City of Bellevue  
Department of Planning & Community Development  
Development Services  
Land Use Staff Report, Environmental Review and  
State Environmental Policy Act Threshold Determination

Proposal Name: Weinstein Stream and Shoreline Restoration

File Number: 06-115928 WG

State Environmental Policy Act  
Threshold Determination: **Mitigated Determination of Non-Significance (MDNS)**

**B** FLOOD CONTROL BERM SECTION  
NTS

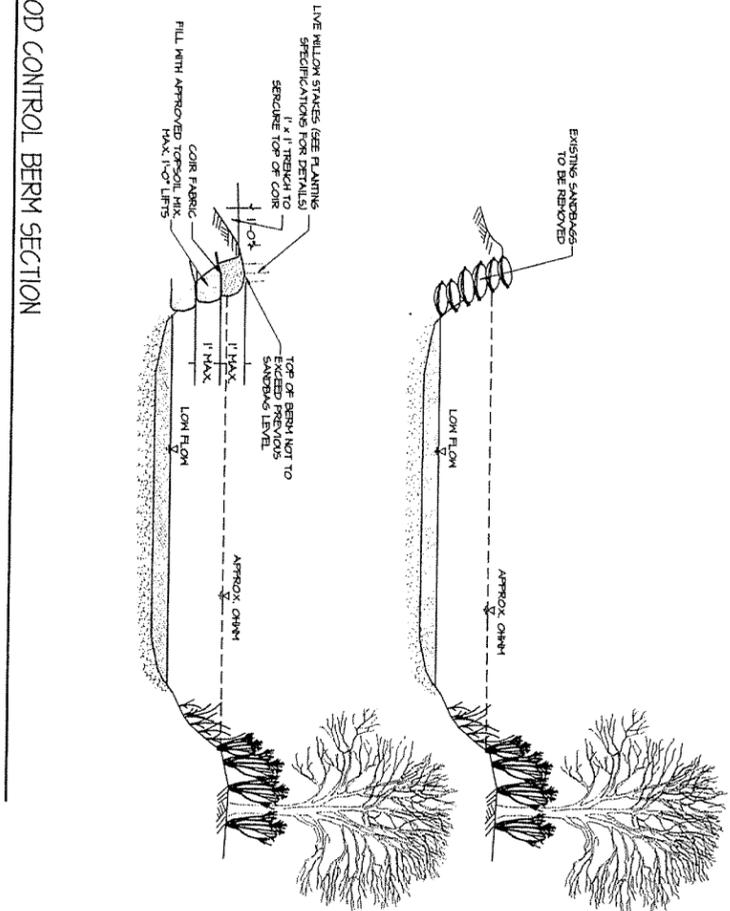
1. ***What is the length of the proposed planted berm on the south side of the stream? What is the existing height of the berm? As proposed 29 cubic yards of coir-wrapped top soil lifts will be placed in this berm, what will be the final height of the berm?***

The elevation of the top of the existing sand bags varies from about 19.7' to about 20.2'. Per the Flood Control Berm detail on the plan sheets, the top of the proposed soil-lift berm will be the same elevation (20 NAVD88 Datum) as the existing sandbag berm.
